Informal Document No.  
(41<sup>st</sup> GRSP, 7-11 May 2007,  
agenda item 3.1.1.)

ECE/TRANS/WP.29/2007/47/[revised](#)  
13 April 2007

Proposal for a draft global technical regulation concerning head restraints

Submitted by the Chairperson of the Working Party on Passive Safety

Figure 1-2

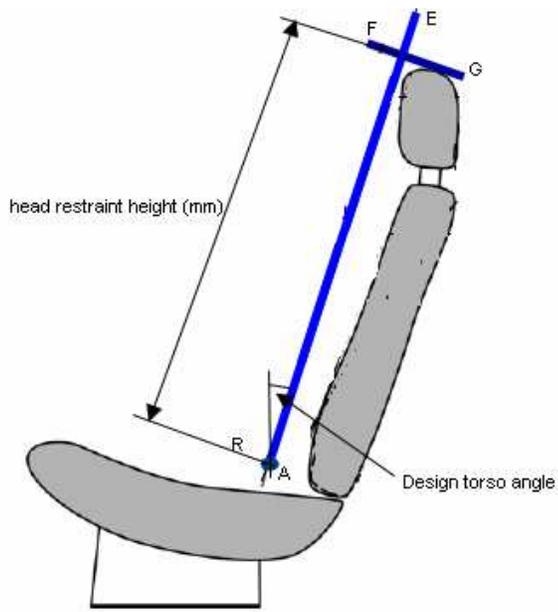
Comment [sm20]: Alliance recommendation. Check minutes, I think this was agreed on.

Figure 3-2

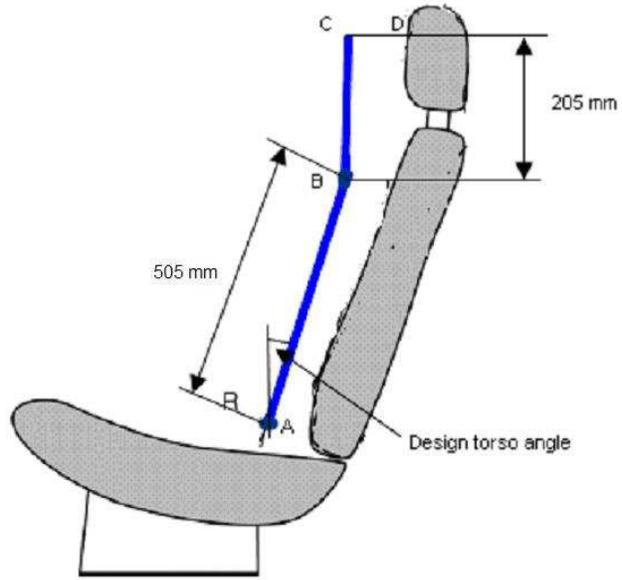
**Comment [sm22]:** Verify the diagram reflects the text. Change 505 to 504.5, change 205 to 203, change design torso angle to design torso angle less 2.6 degrees.

Figure 4-3

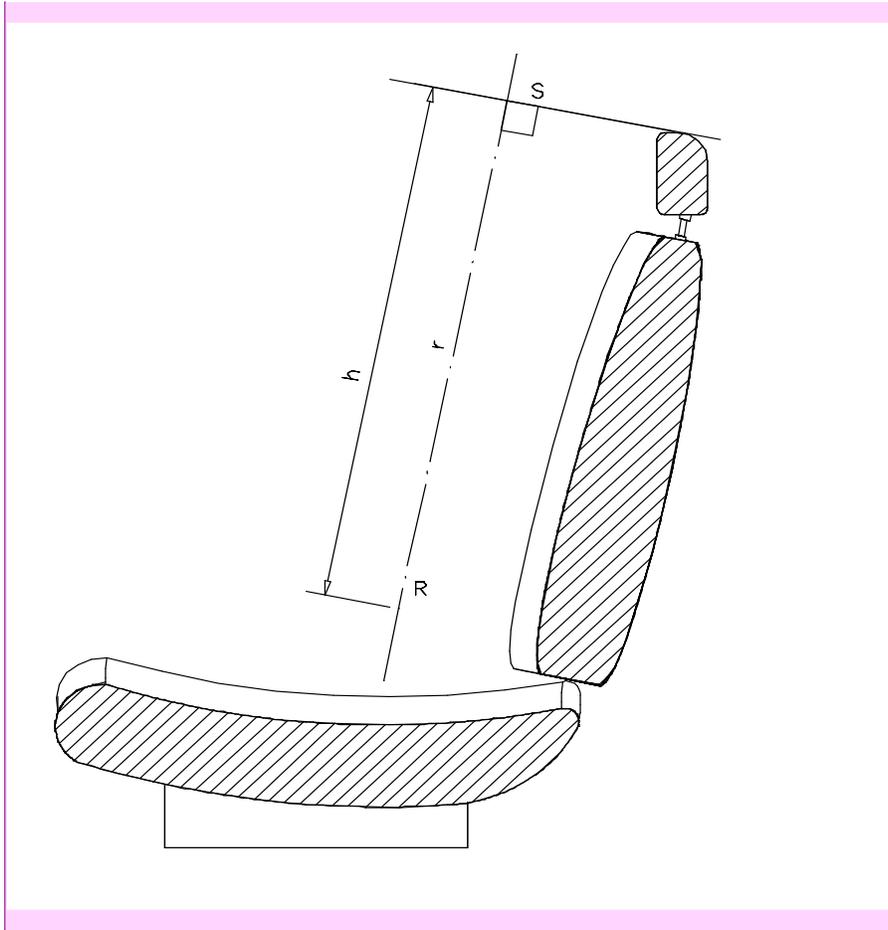
**Comment [sm23]:** Add dimension lines
